Science Research and Education Facility

Australian Institute of Nanoscience
The University of Sydney

Response to Submissions (SSD 5087-2011)

August 2013

Figure 1 Relationship of the modified development to that originally proposed.

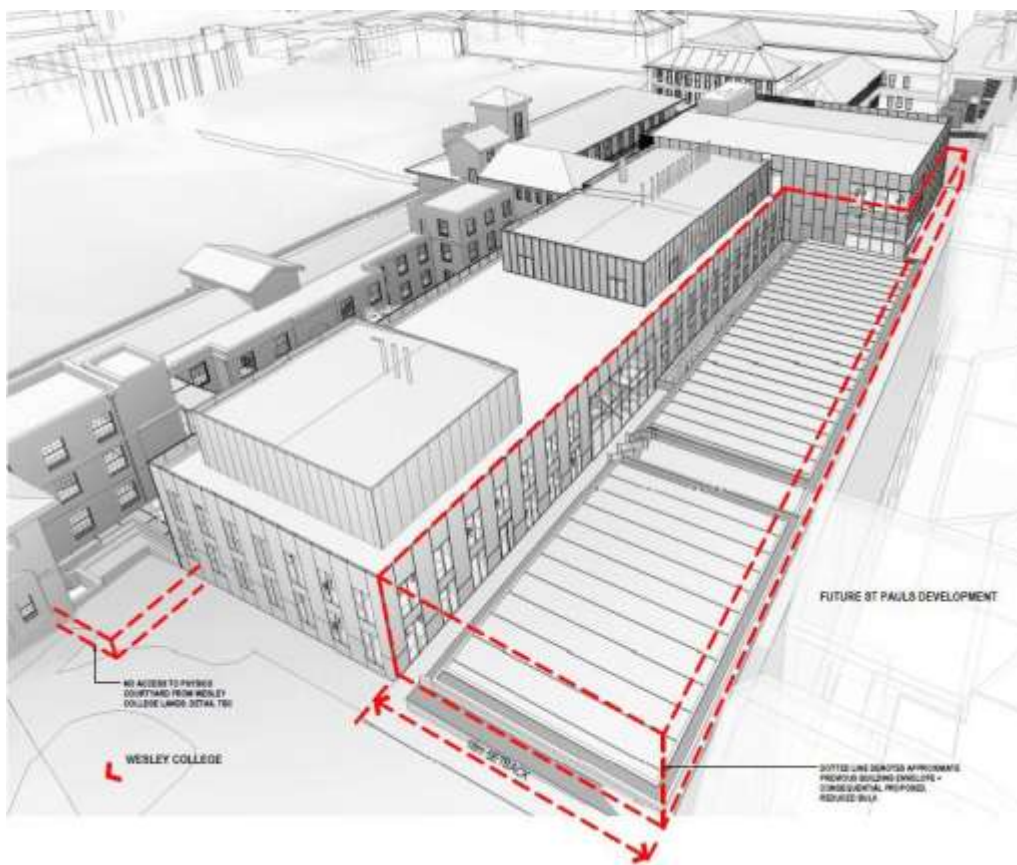
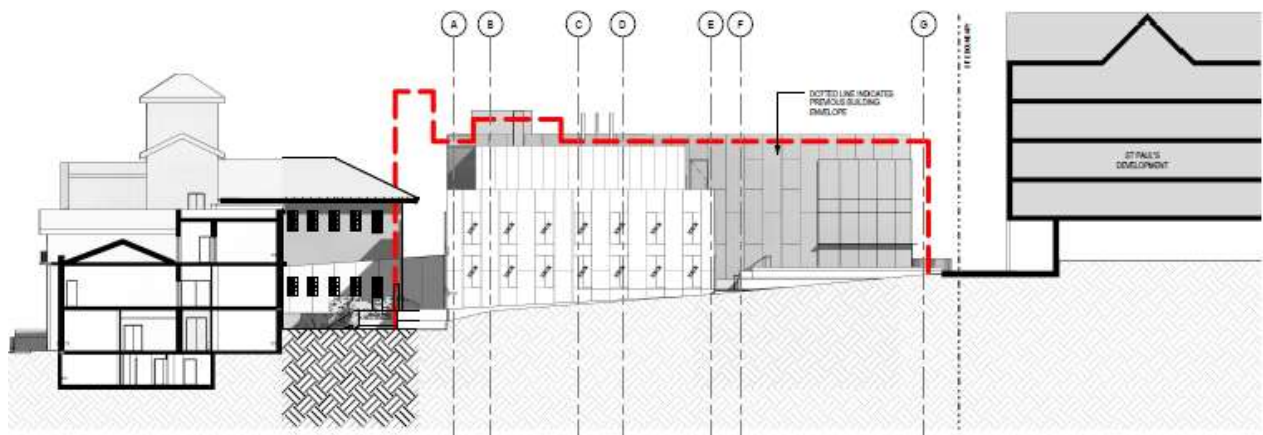
While none of the submissions received objected to the proposed development of the site for the AIN facility, the submissions contain detailed comments and suggestions on various aspects of the building design and its potential environmental impacts. In response to the issues raised in the submissions, and as a result of further detailed design investigations, a number of changes to the design of the AIN facility have been made. However, while the volume, height and bulk of the modified building have been reduced the original functional specification has been retained. Accordingly, the description of the operation of the facility provided in the original EIS is unchanged.

The environmental impacts of the development have been significantly reduced, particularly in terms of:

- Reducing the heritage impact on the adjoining Physics Building to which it is lightly linked;
- Improving the separation between the AIN Building and the proposed St Paul's residential development; and
- Reducing the potential impacts (overshadowing, noise, light spill, pedestrian congestion etc) on the adjoining Wesley College.

The main changes incorporated into the revised design include:

- A change to the size, location and shape of the AIN Building's footprint;
- The western wing is symmetrically positioned to provide a 20m visual opening on the Wilkinson Axis;

- The setback of levels 2-4 of the AIN Building's southern facade has been increased by 18m from the southern site boundary;
- The separation between the AIN Building and the Physics Buildings (A28) has been increased;

- The linkages between the AIN Building and the existing Physics Building (A28) have been reduced to a single level;
- A green roof has been added to level 2 of the AIN Building opposite St Paul's proposed development;

- The eastern overhead pedestrian bridge has been replaced by an external stairway engaged with the eastern side of the AIN Building; and
- Consequential internal changes to the distribution of activities within the AIN Building by eliminating the internal court yard and relocating the ground floor cafe, concentrating like functions where possible and moving the main lecture theatre closer to the eastern end of the building, all of which have consolidated the extent of the building.

Figure 1, 2 & 3 show that compared to the original design, the proposed AIN Building:

- The building has a smaller footprint;
- The building is generally lower in height and the taller elements are concealed behind the eastern wing of the Physics Building;

- The depth of the building is significantly less – providing a greater separation from the existing Physics Building, the proposed St Pauls development and a smaller facade to Wesley College; and
- The north-south pedestrian link has been joined and integrated with the AIN Building.
